DEVELOPMENT MANAGEMENT COMMITTEE 15th December 2025

Case No: 25/00885/LBC

Proposal: Proposed conversion of outbuilding to dwelling

Location: 50 High Street, Brampton, PE28 4TH

Roof Framing Plan.

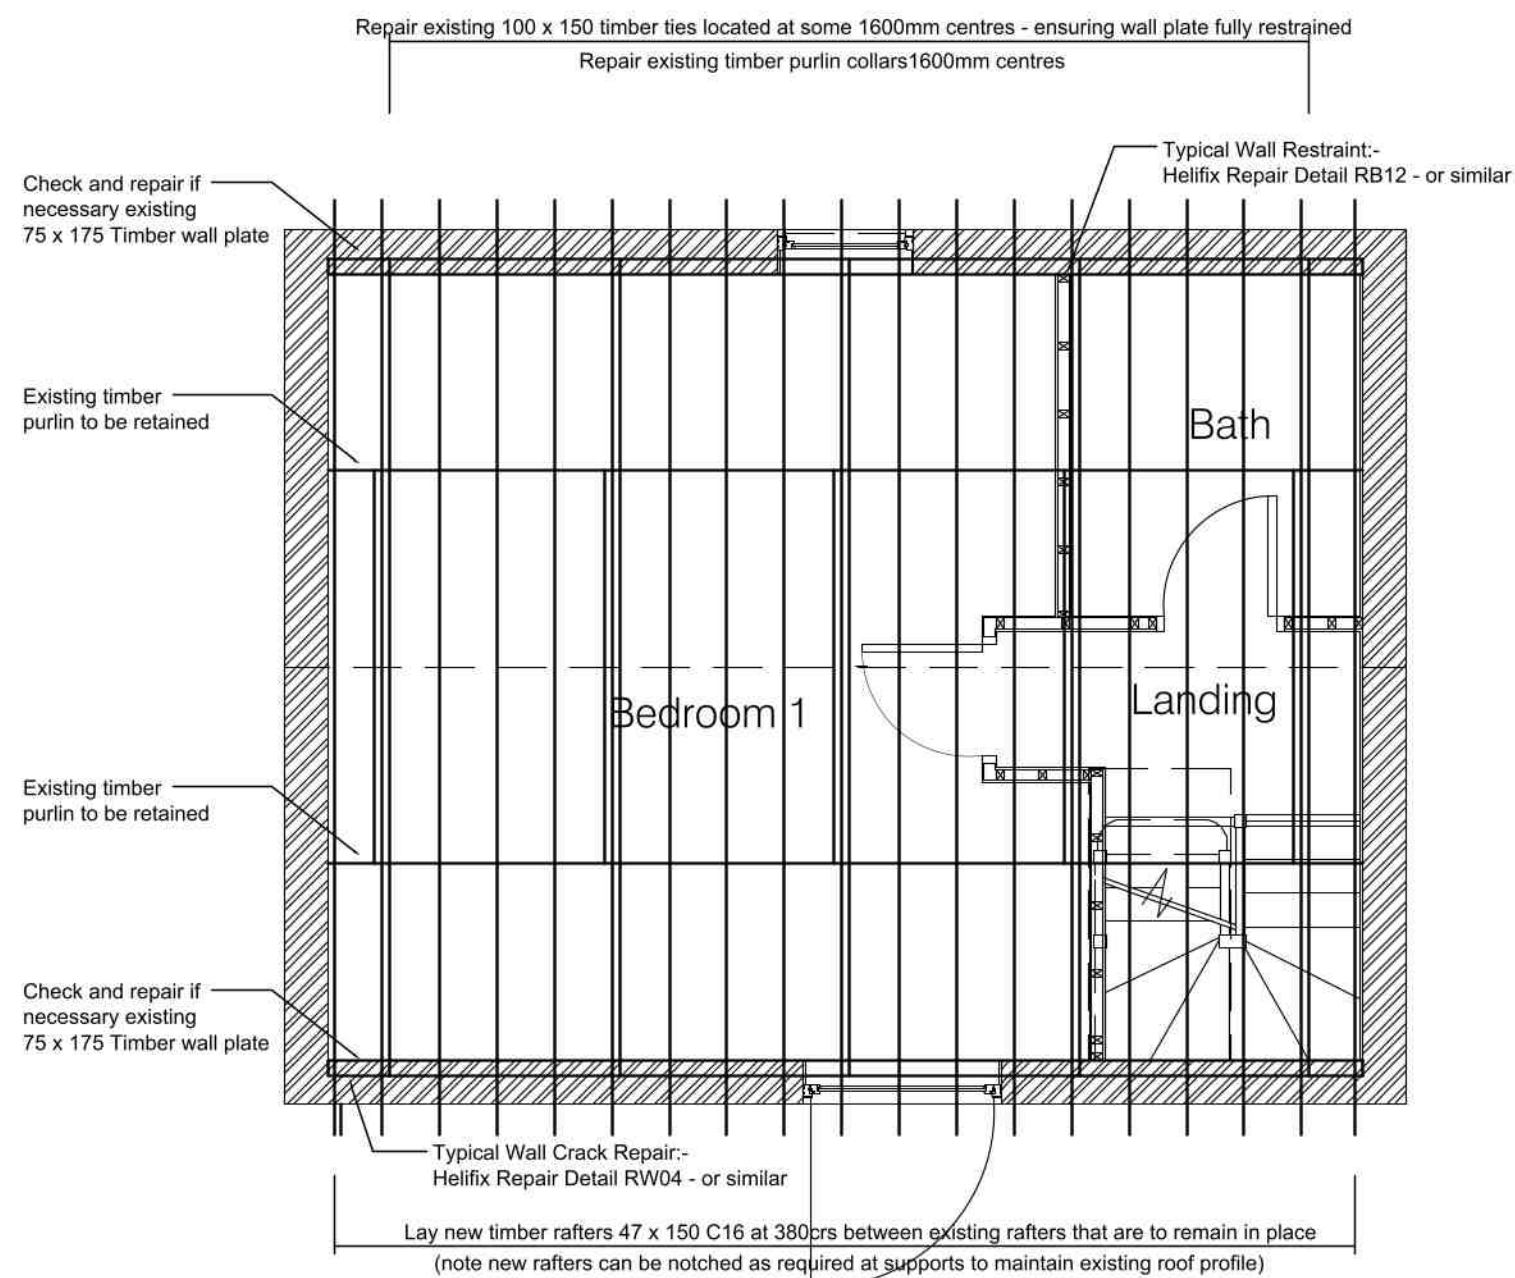
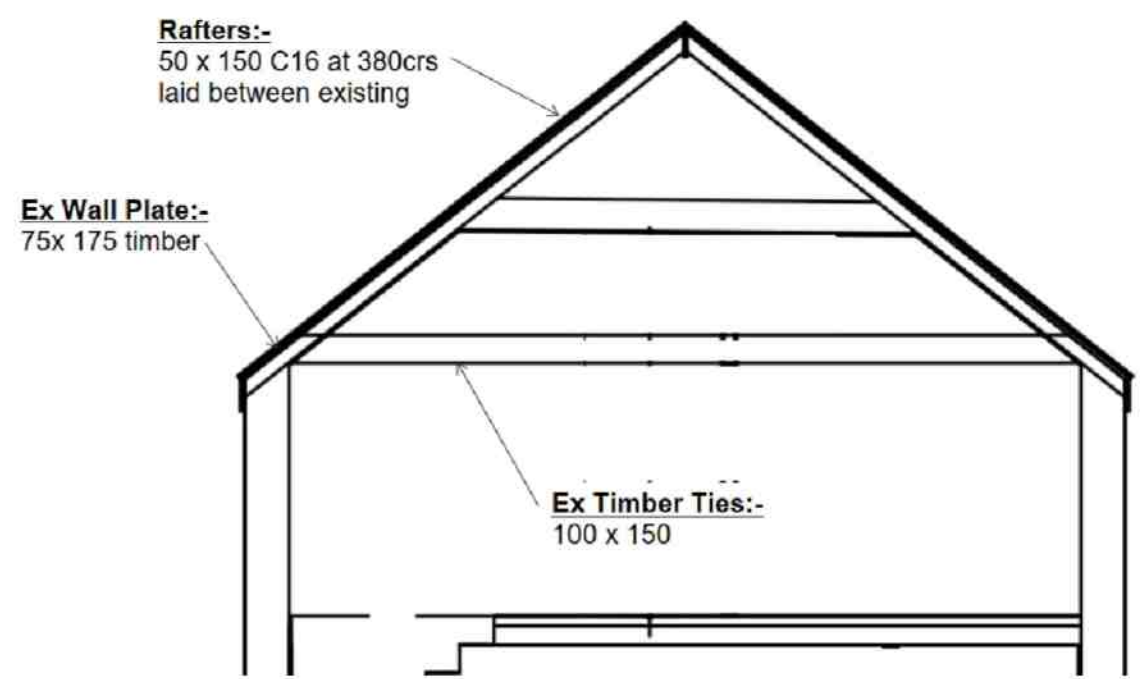
- Roof inspection and repairs. There is no indication that a detailed roof survey has been conducted to identify defects. It is unclear what works will be required to the roof. The drawing submitted in September 2025 suggest that each rafter will be doubled up with new laid between existing. There are concerns that the roof will need to be stripped (no details) and no details of how this will be insulated.

- Constructional calculations are unclear. Appropriate scaled drawings have not been provided. Details appear to suggest the insertion of additional new rafters into the roof – this would necessitate the stripping and relaying of the roof these works are not indicated on the drawings.

First Floor Framing Plan.

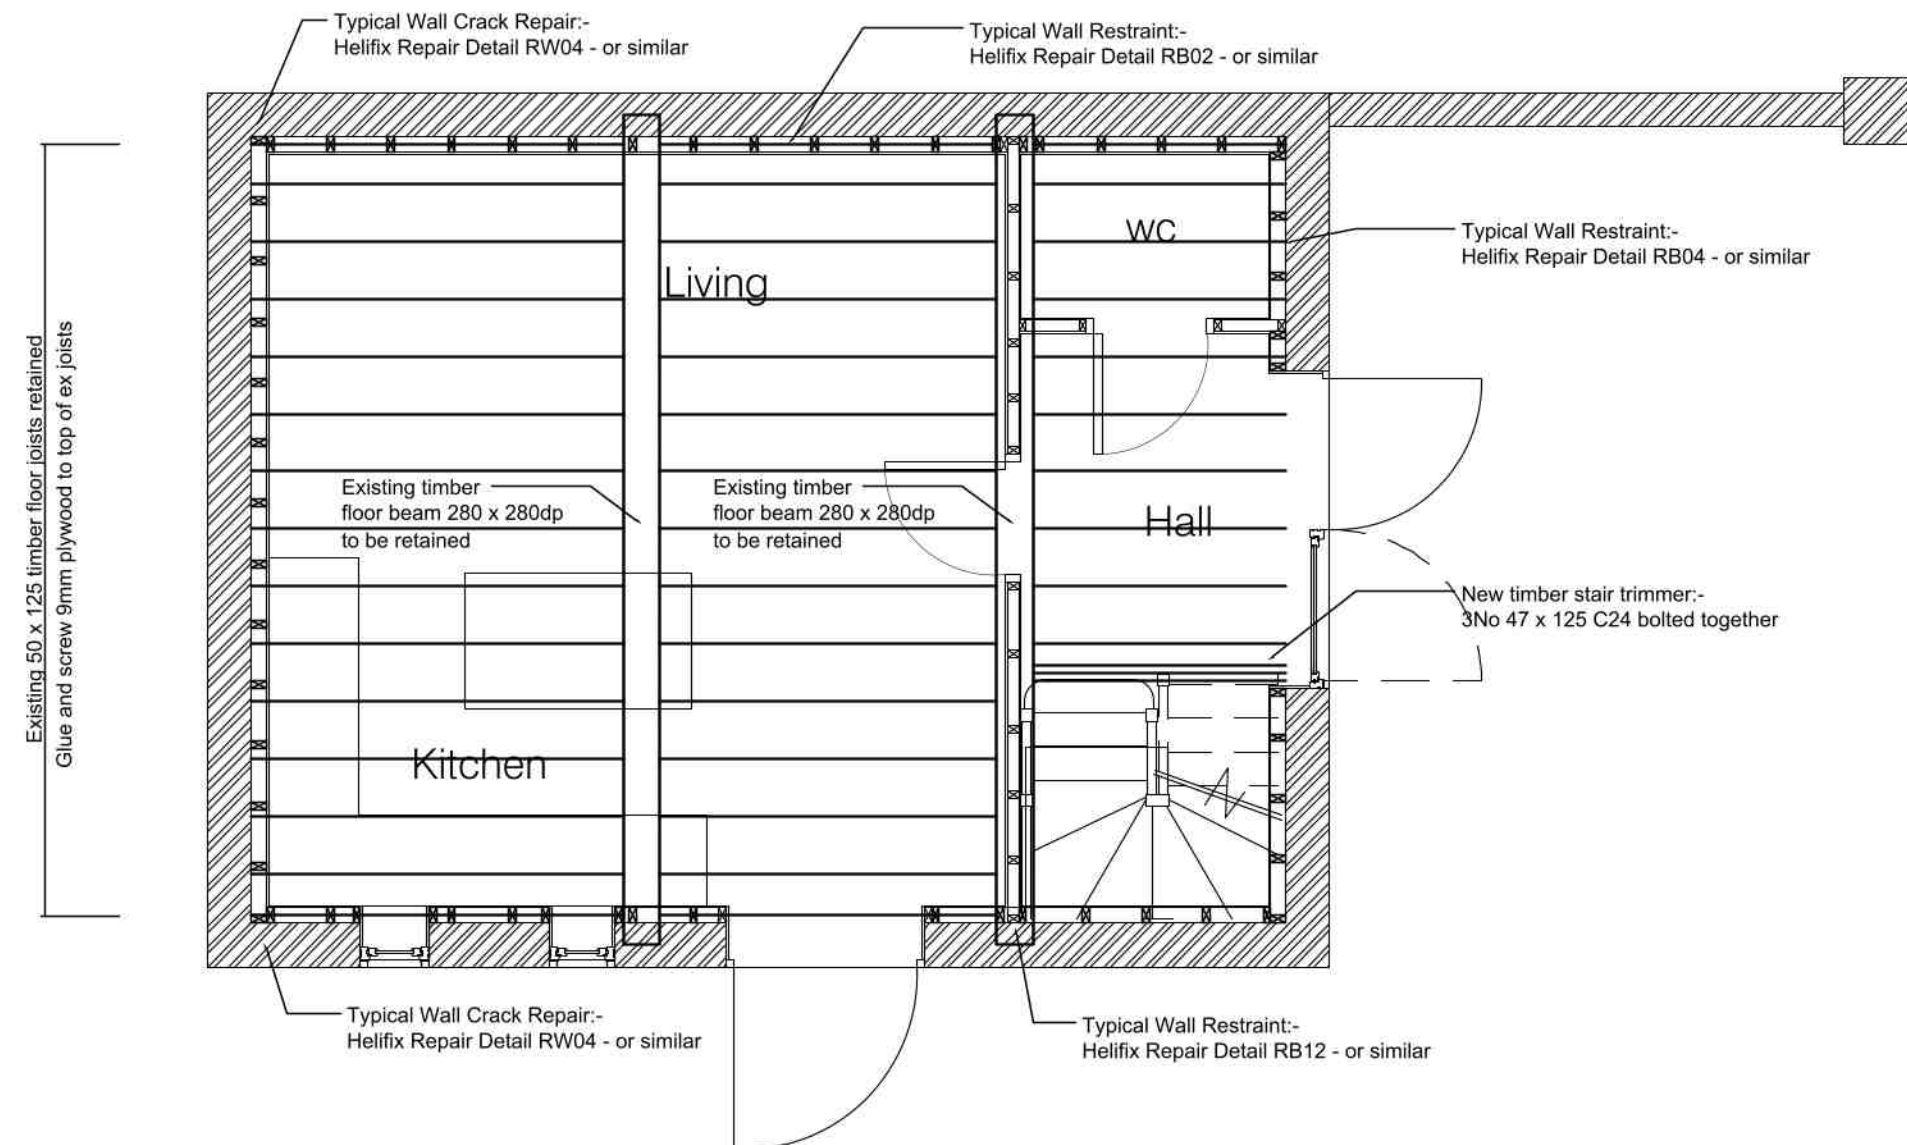
- No details of the proposed new ceiling. Where it would be, what is proposed and impact on beams.
- Unclear if the first-floor structure is to be retained or replaced and if it could cope with the loading capacity for residential use or if historic downstand beams be retained.

Ex Foundation/Ground Floor Detail. [1:25]

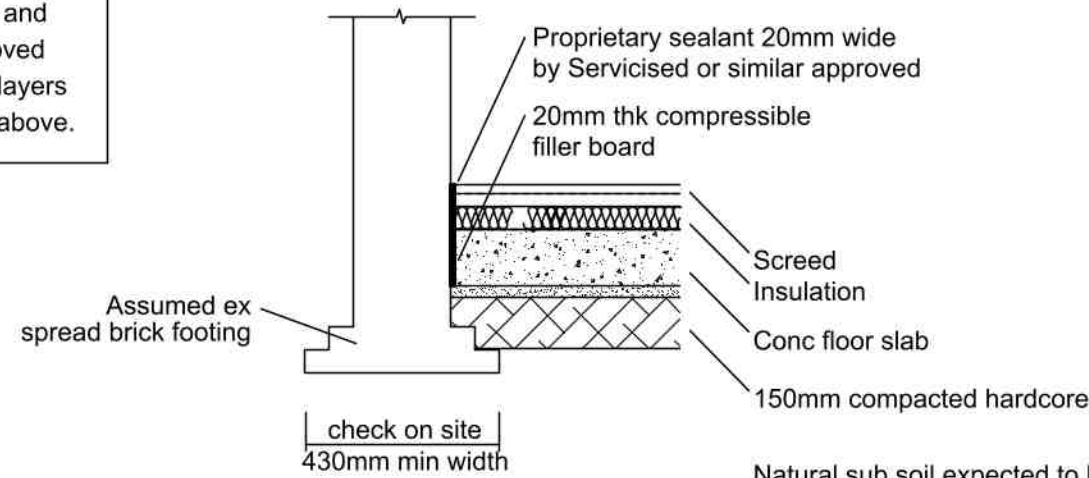
- Indicative drawings have been provided (not to scale) regarding the foundations of the building. There is no way to understand the impact on the levels within the building. Annotations suggest that the floor will be reinforced concrete with a polythene damp proof membrane. This will then force any damp up the walls of the building as no damp proof course has been proposed. Neither of these systems are appropriate for a listed building. Evidence provided in September 2025 indicates that the entire structure will be dry lined. No details of any insulation is provided. These works would fundamentally undermine the character of the building.
